TOWN OF VERNON
Inland Wetlands Commission (IWC)
Meeting Notice & Agenda
Tuesday, February 22, 2022, 7:00 PM

4.1 IWC 2022-01, 501 Talcottville Rd. An Application by Vernon Development LLC for a Wetlands Re-designation and a Wetlands Permit for activity in a regulated area, in order to develop a child-care facility at 501 Talcottville Rd. (Tax Map 09, Block 007, Parcel 0001D).

Re: The Learning Experience (TLE)
501 Talcottville Road, Vernon

TO: Town Of Vernon Inland Wetlands Commission
George McGregor - Town Planner

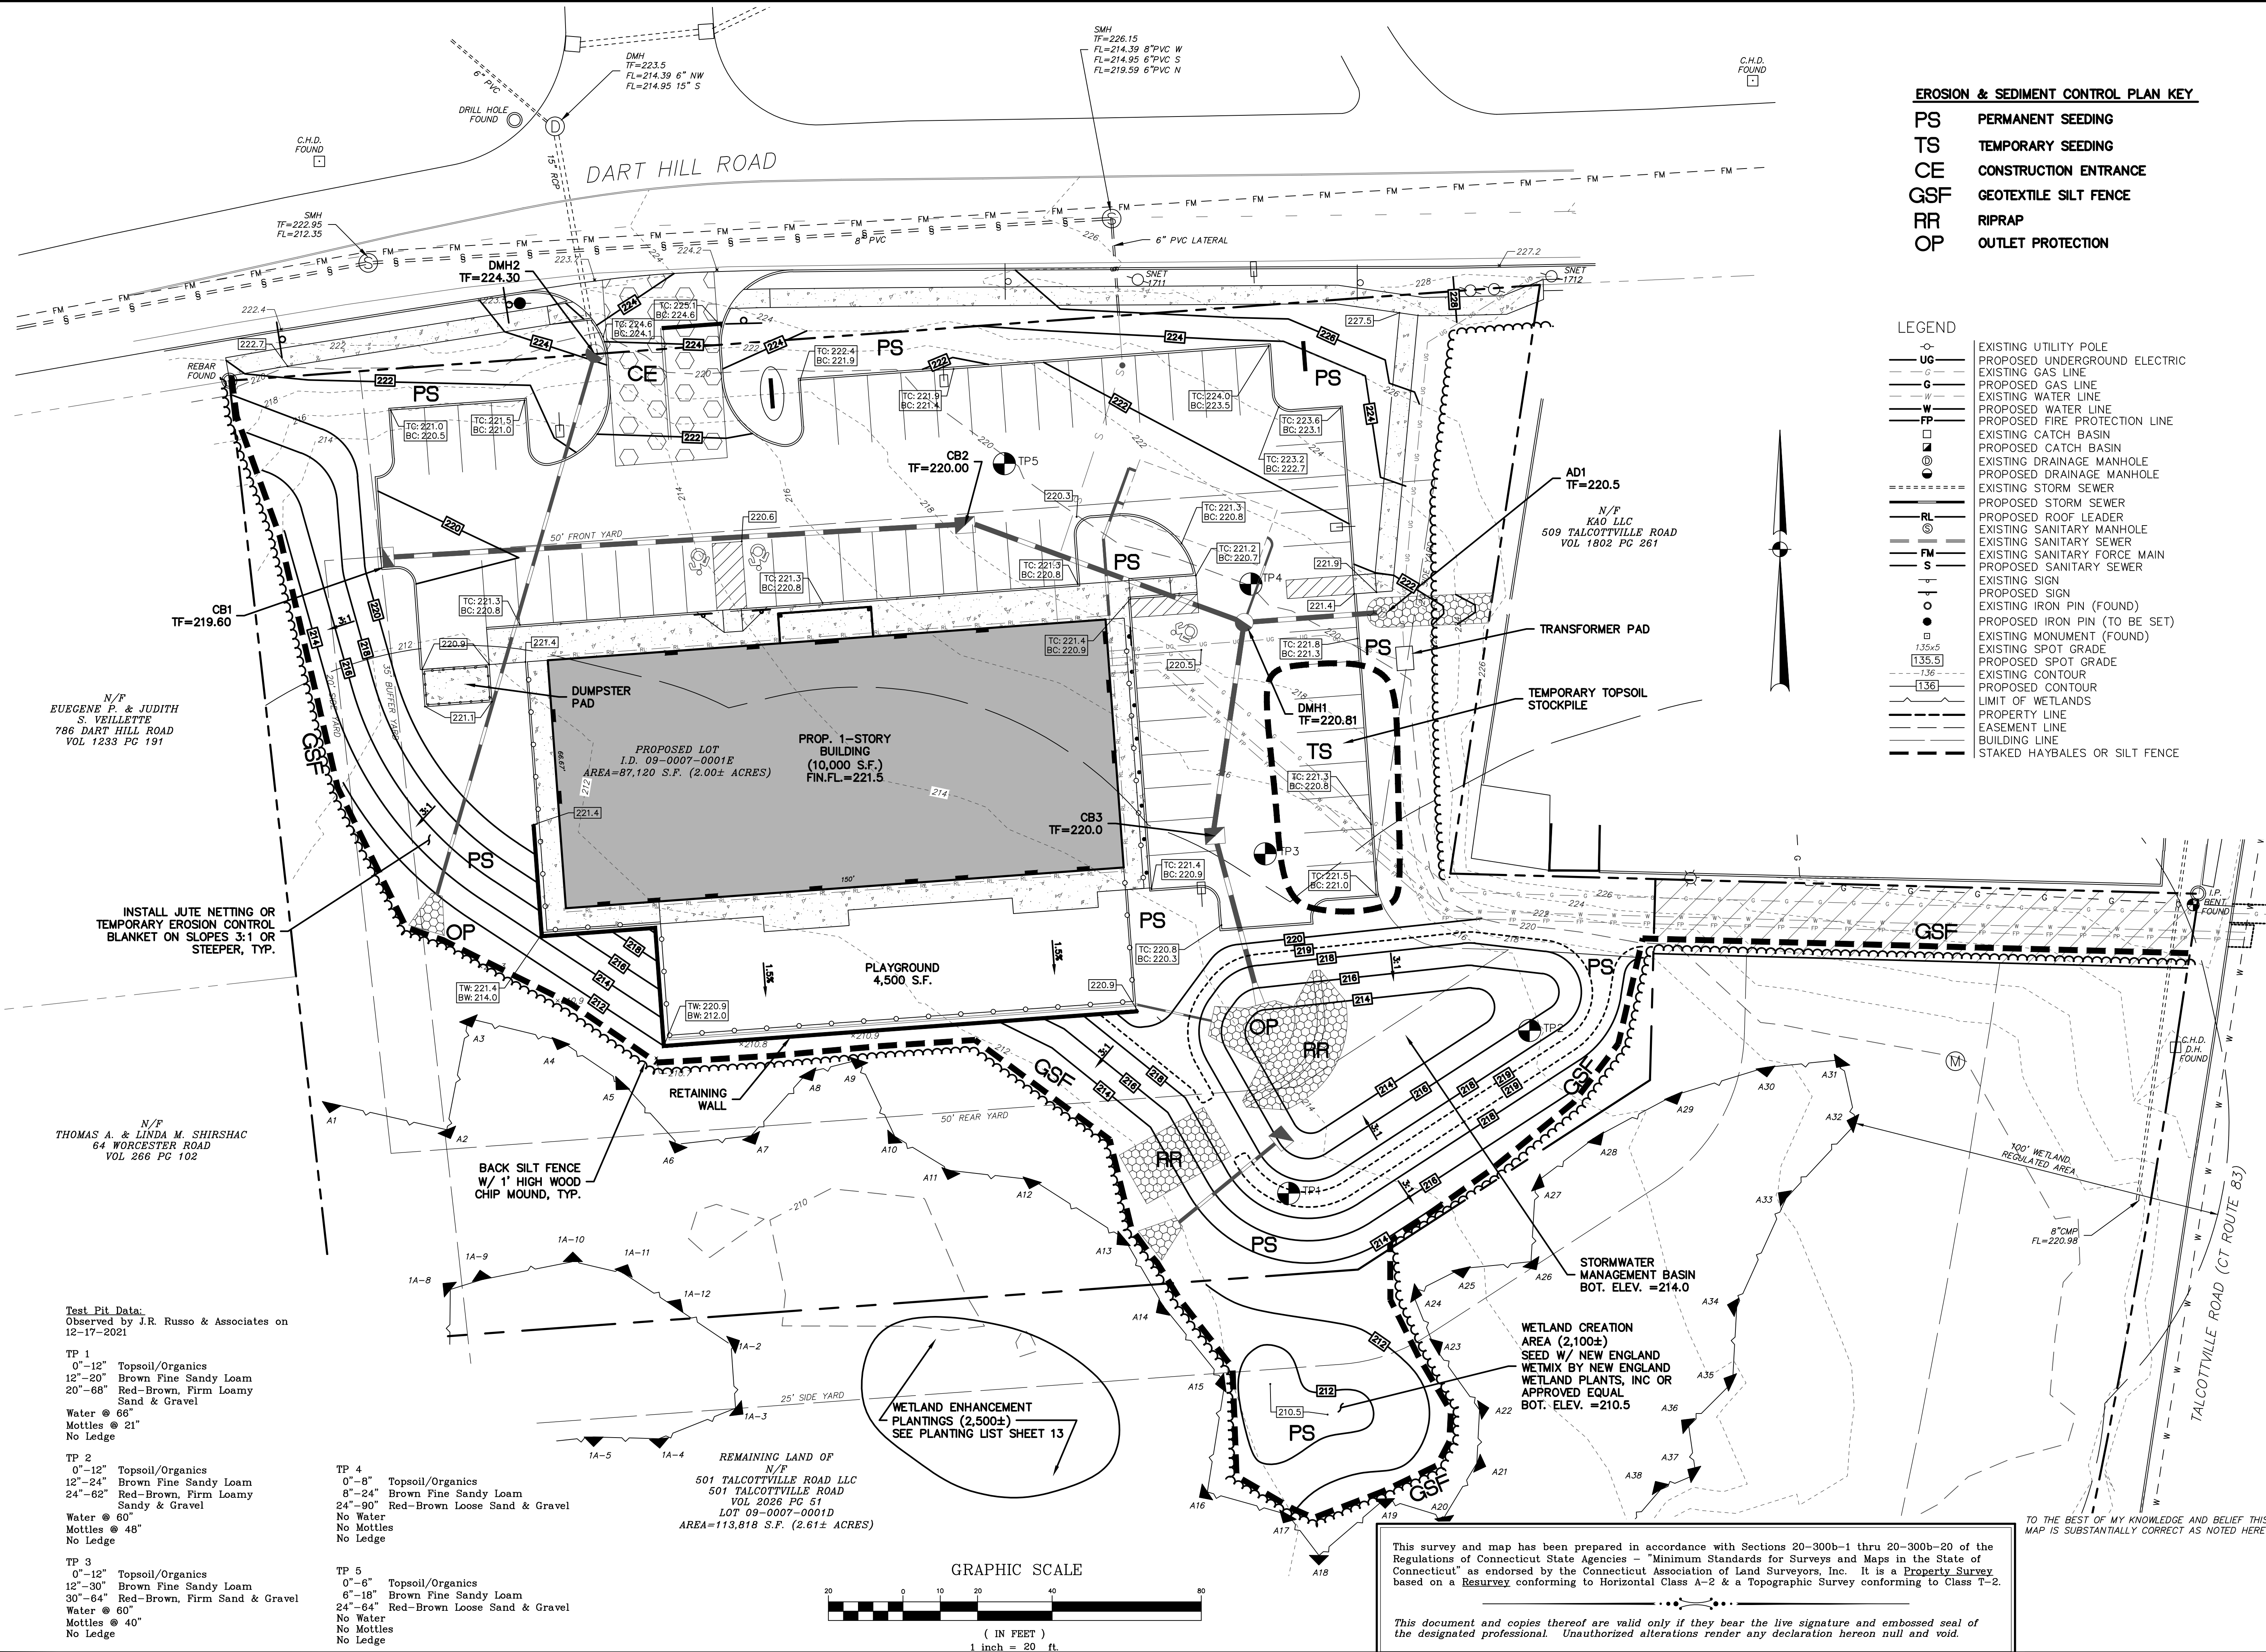
- In referencing the Grading / Erosion and Sediment Control Plan, there is a significant amount of proposed site disturbance, depositing of fill material, and other construction activities associated with this project that are shown within a few feet of the wetland areas. I do not believe it is realistic to expect the erosion and sedimentation controls to prevent any impacts to the wetlands during heavy rain events when the installation is proposed in such close proximity to the wetland boundary itself. It has been my experience that a single row of silt fence is very limited in preventing impacts to the

1. Despite the significant amount of fill required at the site, the runoff across the site will be very limited based on the existing sandy soils and limited distance across the site. It is believed that a single silt fence, if maintained properly, is sufficient to protect the downgradient wetland from sedimentation and erosion. However, based on Mr. Perry's concerns, the plans have been revised to include the placement of a wood chip berm to back up the silt fence installed at the edge of the downgradient wetland.

2. The plans have been revised to extend the sediment barrier (silt fence backed by a wood chip berm) along the utility corridor out to Talcottville Road.
